SUBJECT: COMANCHE PEAK STEAM ELECTRIC STATION (CPSES)
DOCKET NOS. 50-445 AND 50-446
ADVANCE FSAR SUBMITTAL, FIGURE 9.4-3, TURBINE
BUILDING VENTILATION FLOW DIAGRAM

As part of Amendment 76, changes were to be made to Figure 9.4-3, Turbine Building Ventilation Flow Diagram. The revised Figure 9.4-3 was inadvertently omitted from Amendment 76, however a description/justification for each change to this figure was included in the Amendment 76 description/justification letter. (See Attachment 1 for a markup of the related changes.)

Figure 9.4-5

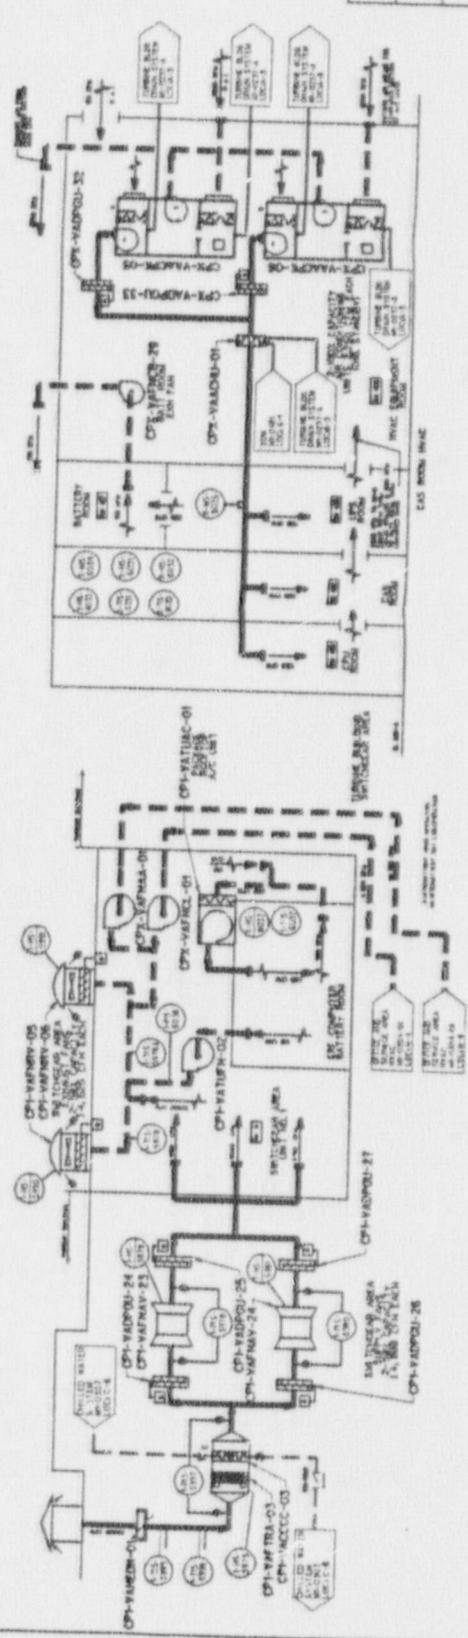
Description: (Correction)

Correct drawing to show one pressure switch rather than two for each pre-access filtration unit, to reflect as-built condition.

Only one pressure indication switch is provided for each unit to monitor high pressure differential across the unit.

REF: 2323-M1-0306 CP-6 AND FSAR FIG. 9.4-3

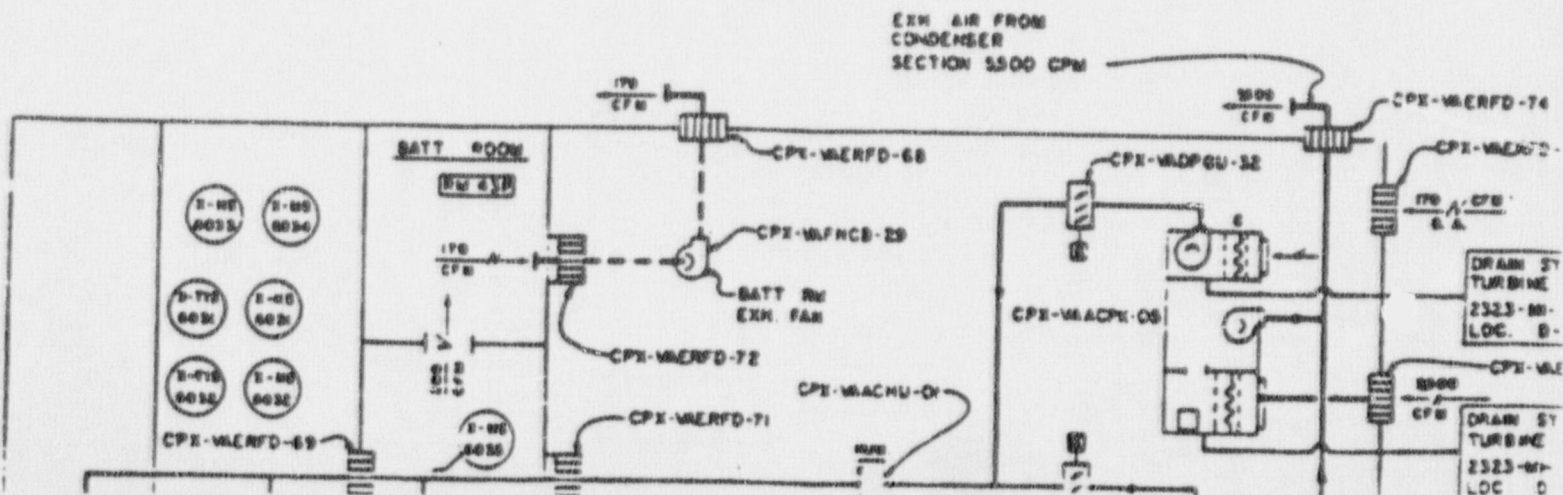
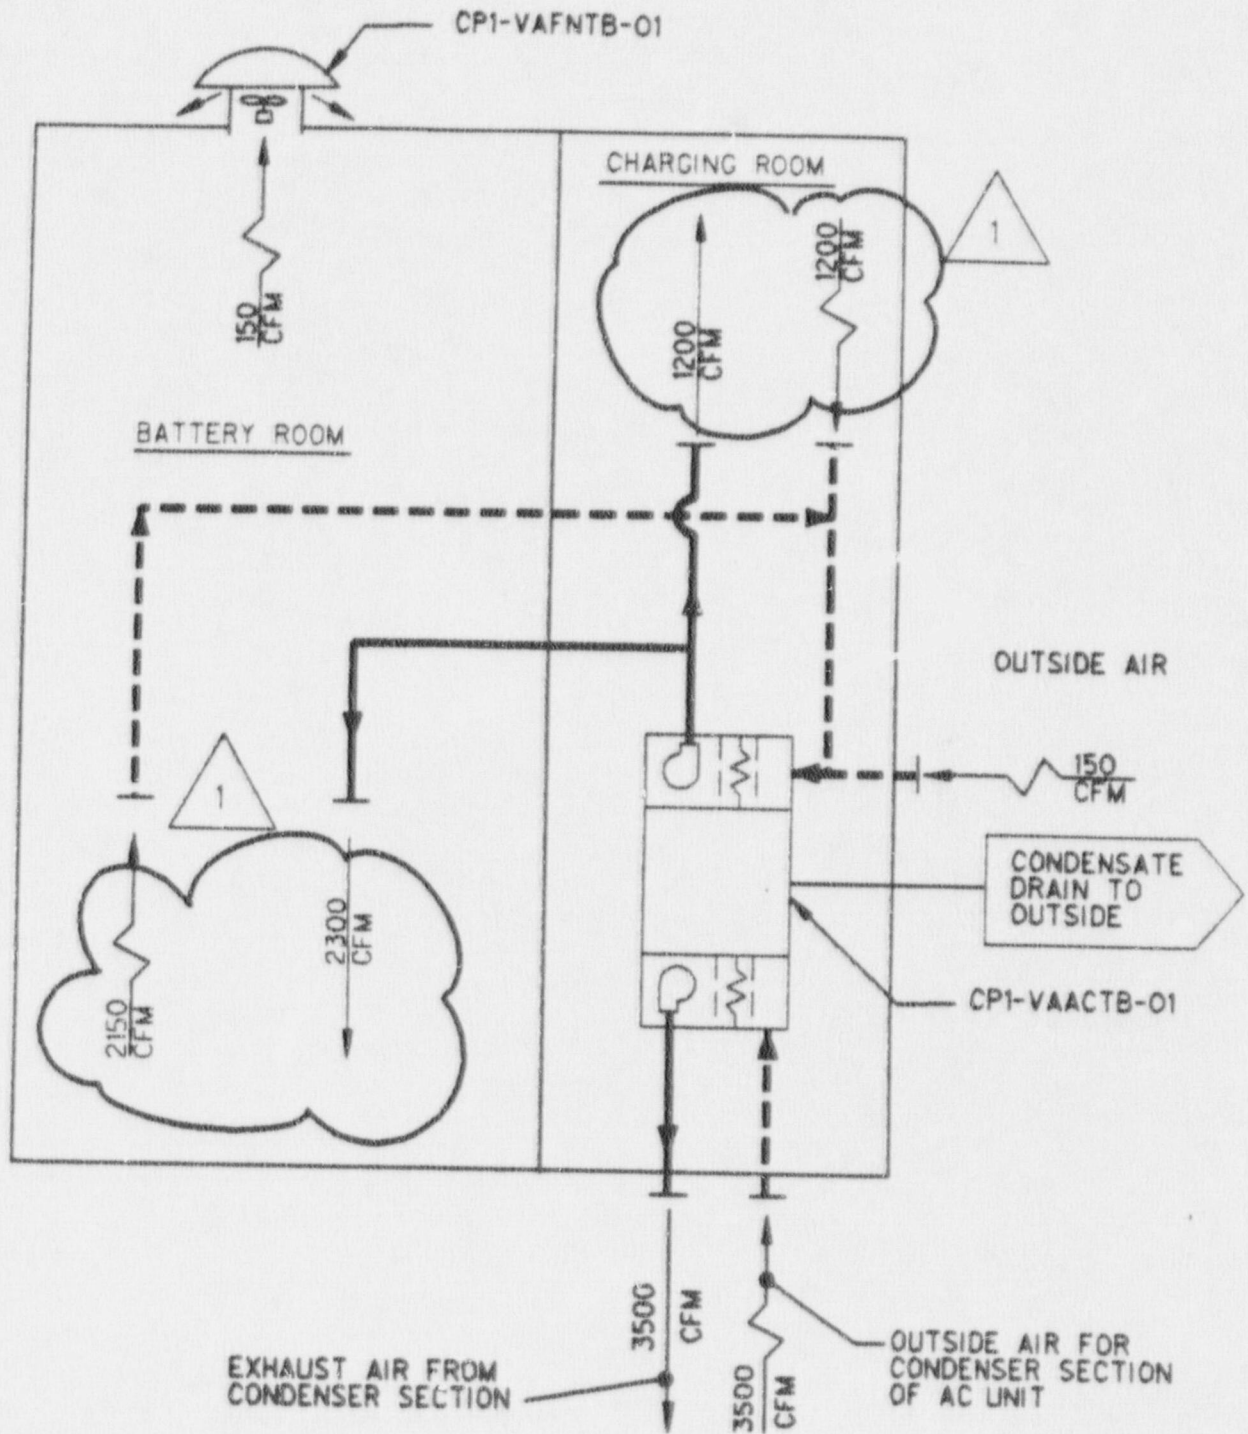
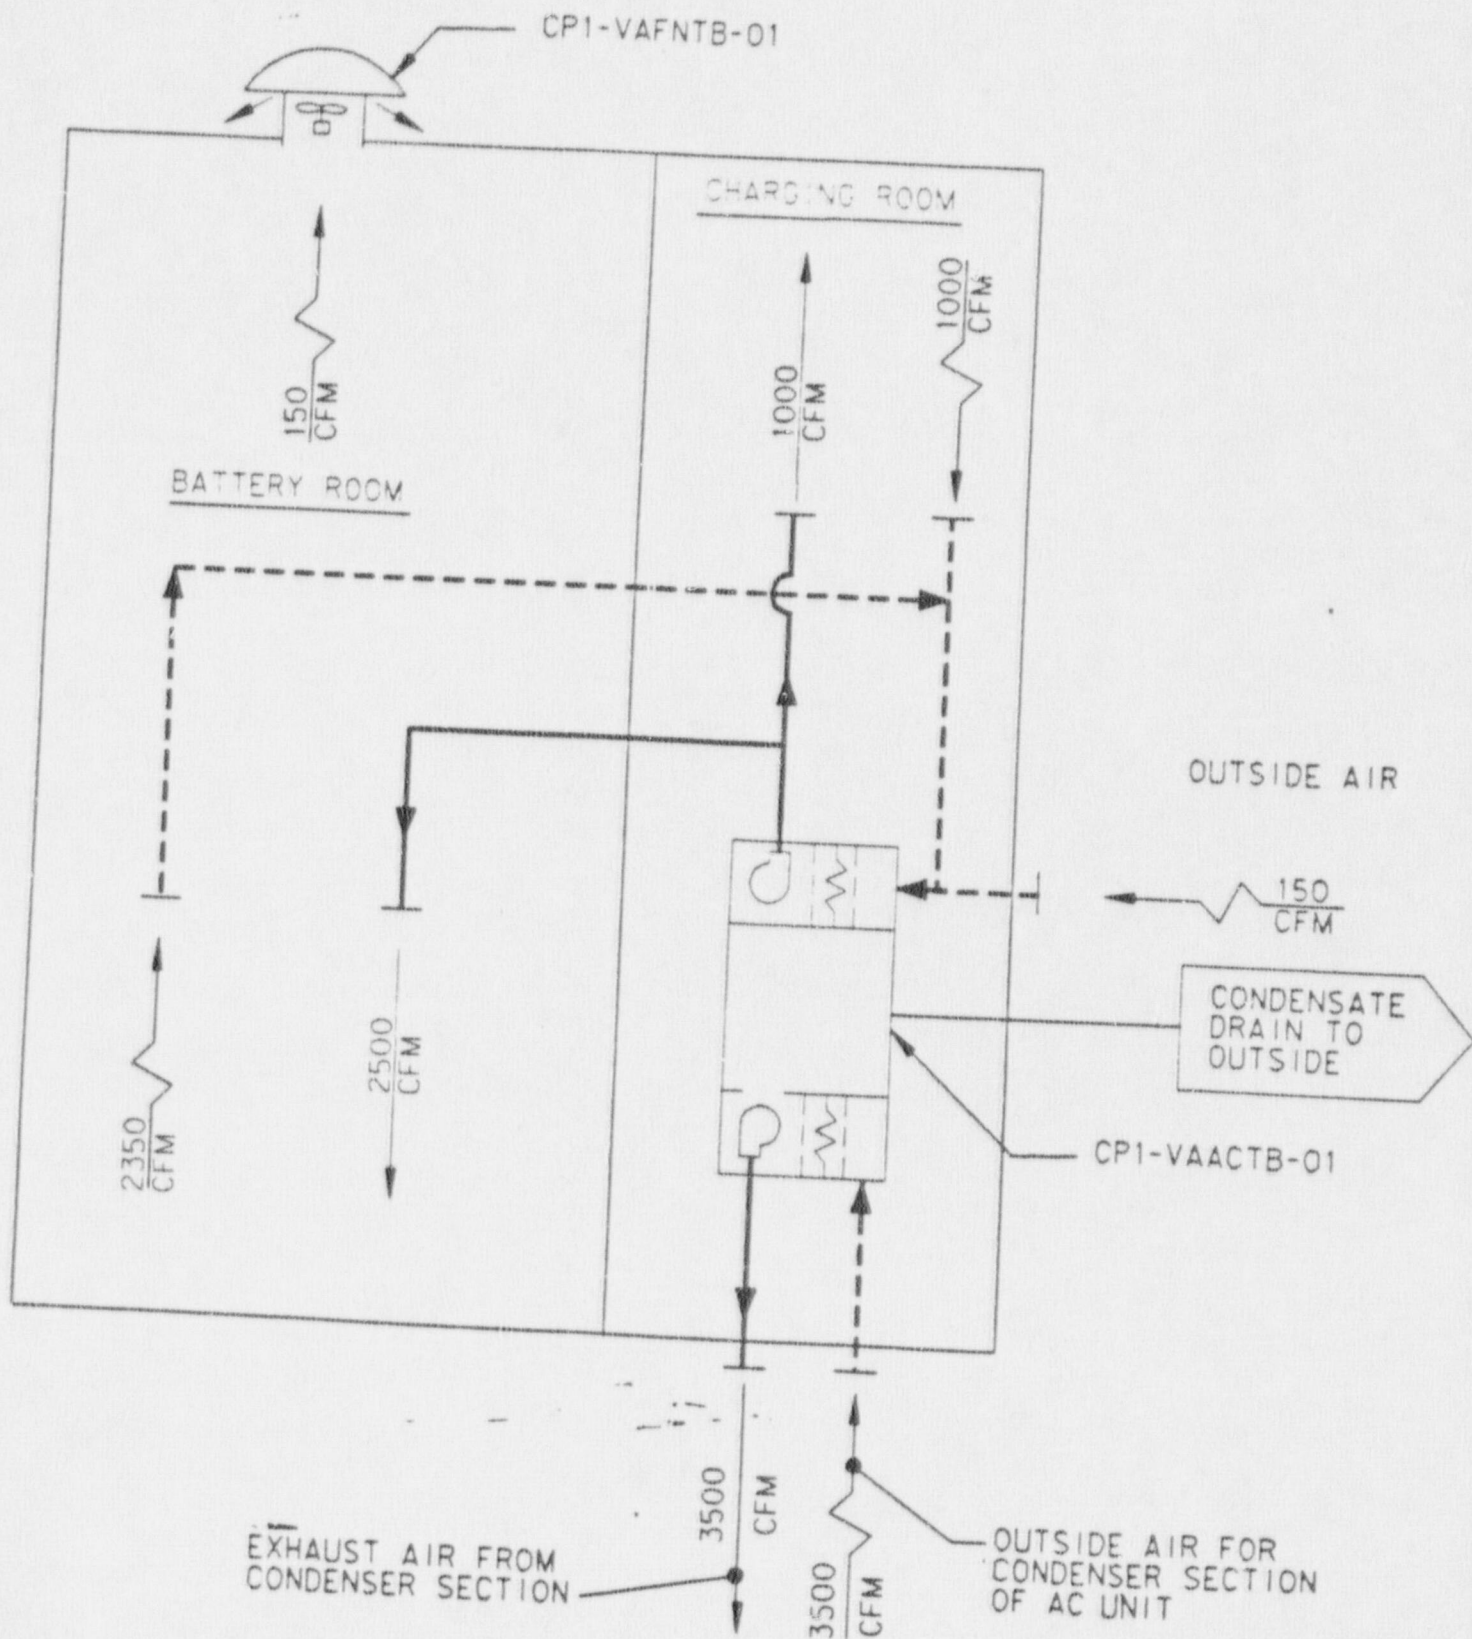
Description: (Revision)

Adds a non-safety related Battery Room HVAC System for
the new Battery Room and Charging Room. The new
Battery and Charging Room equipment is backup to
provide DC power to the emergency lighting in the
Control Room.
